AREAS OF CONCERN

1 Site Plan
1" = 50'-0"

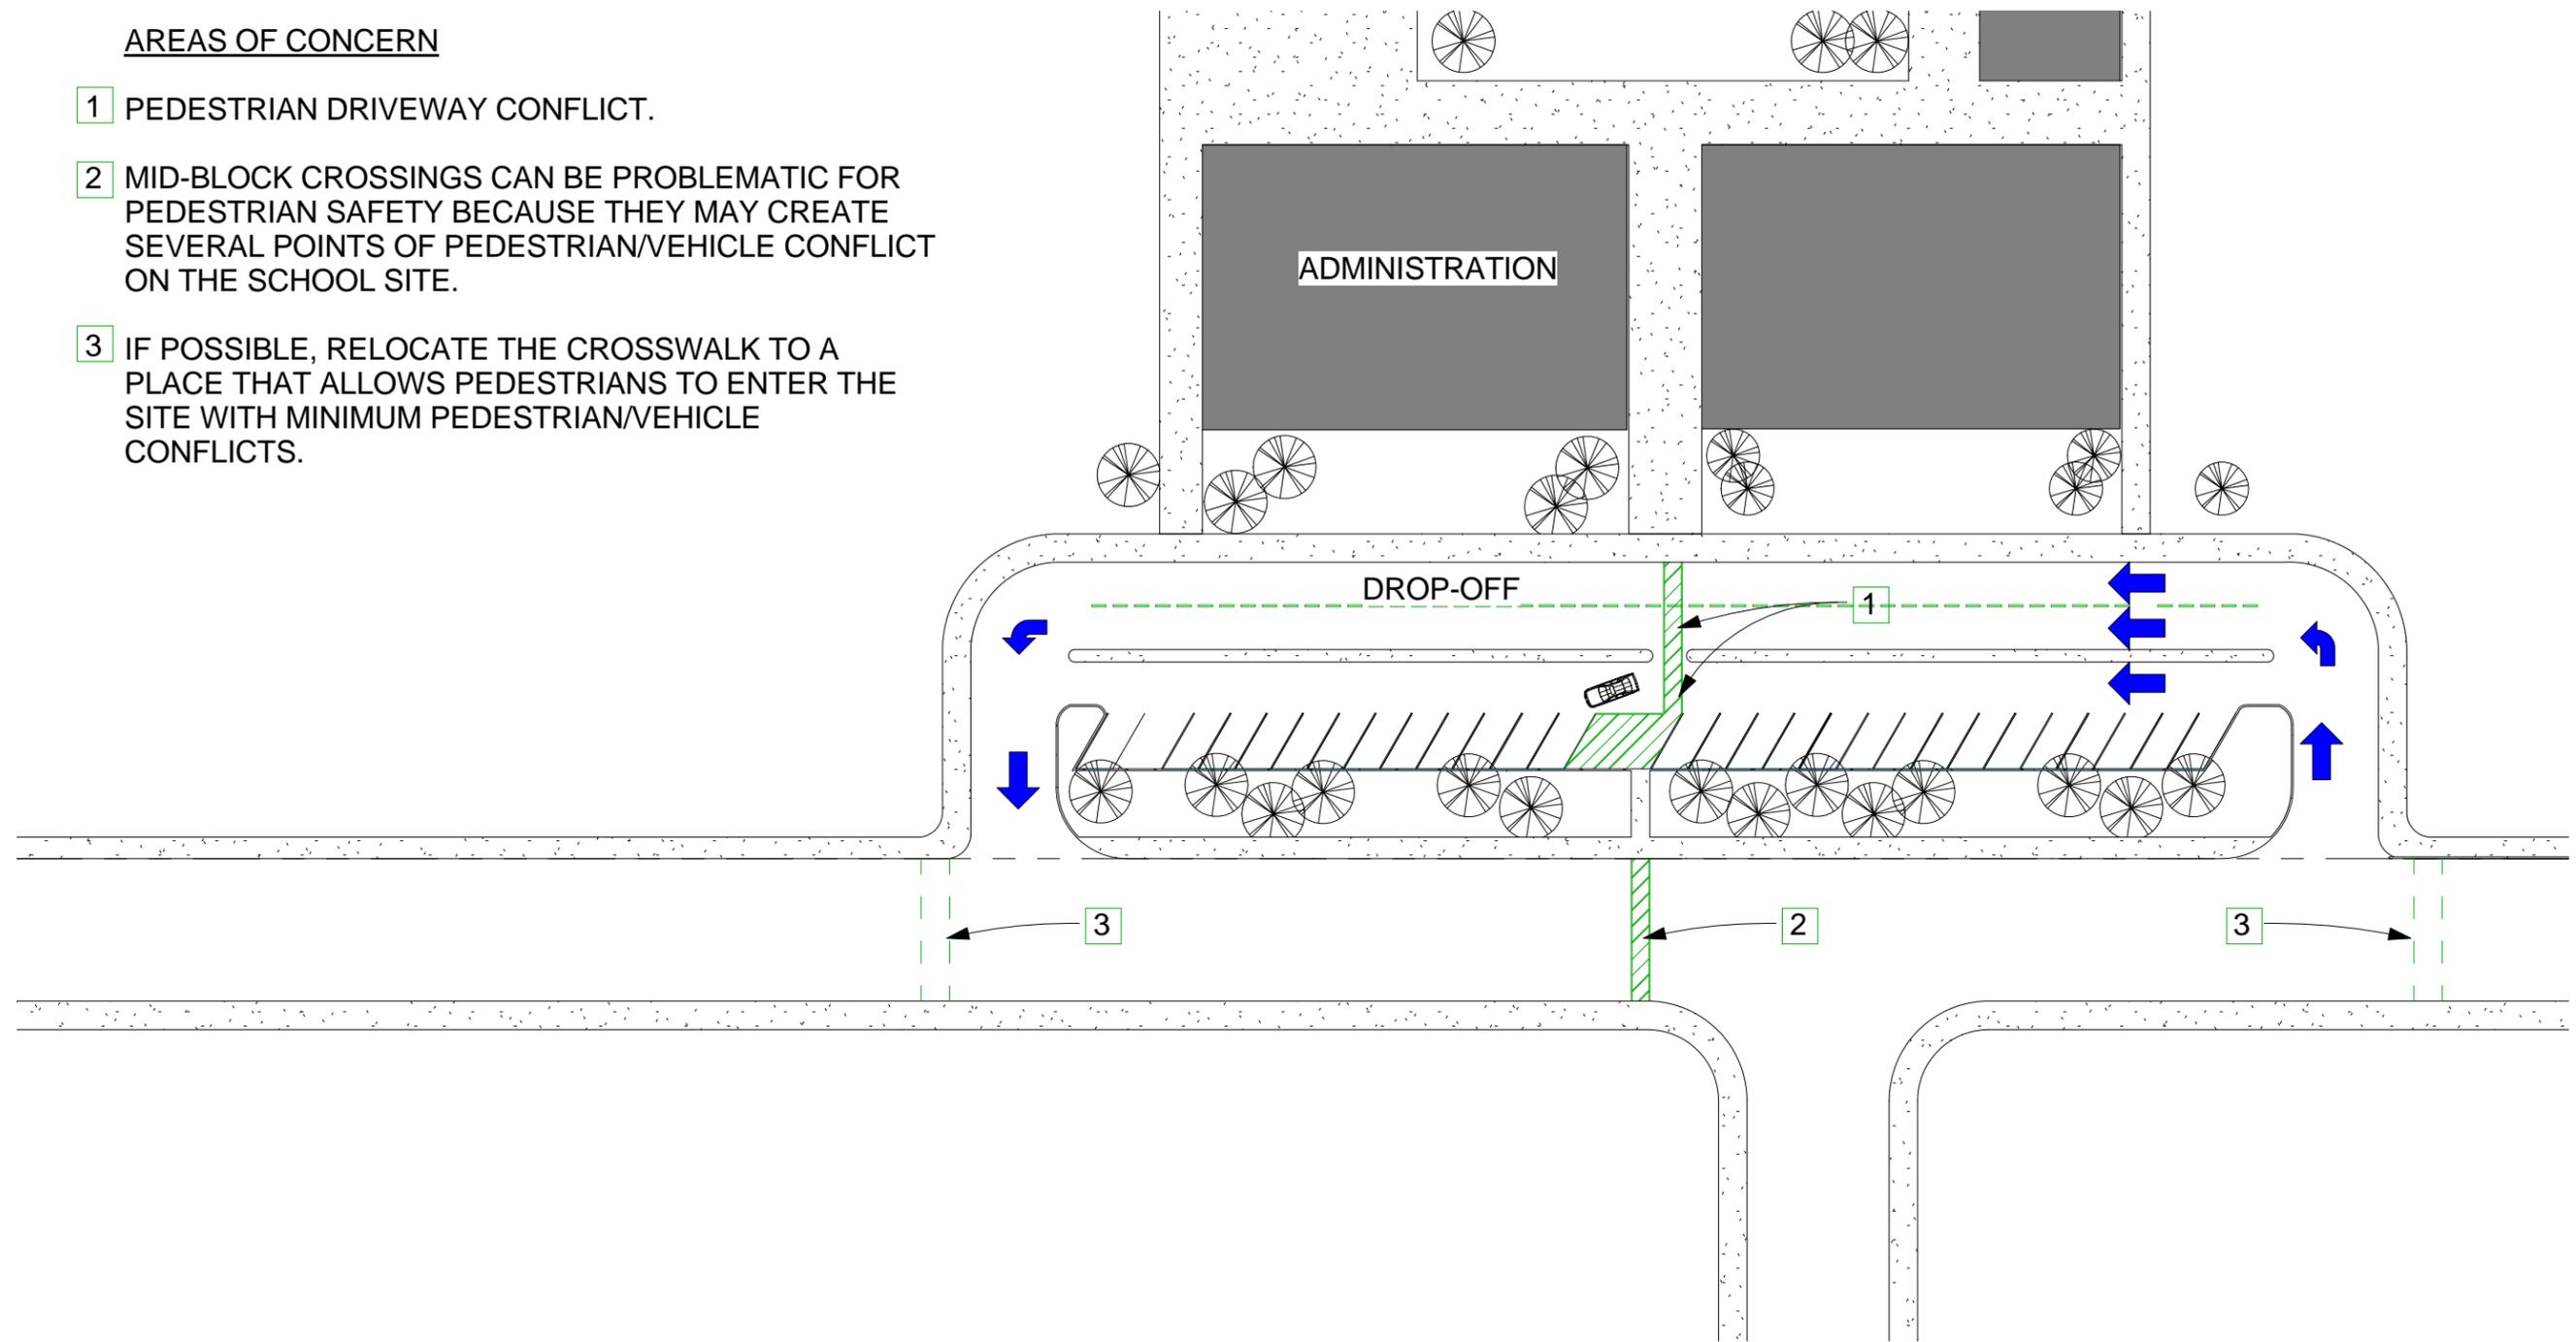
- 1 PEDESTRIAN DRIVEWAY CONFLICT.
- 2 MID-BLOCK CROSSINGS CAN BE PROBLEMATIC FOR PEDESTRIAN SAFETY BECAUSE THEY MAY CREATE SEVERAL POINTS OF PEDESTRIAN/VEHICLE CONFLICT ON THE SCHOOL SITE.
- 3 IF POSSIBLE, RELOCATE THE CROSSWALK TO A PLACE THAT ALLOWS PEDESTRIANS TO ENTER THE SITE WITH MINIMUM PEDESTRIAN/VEHICLE CONFLICTS.
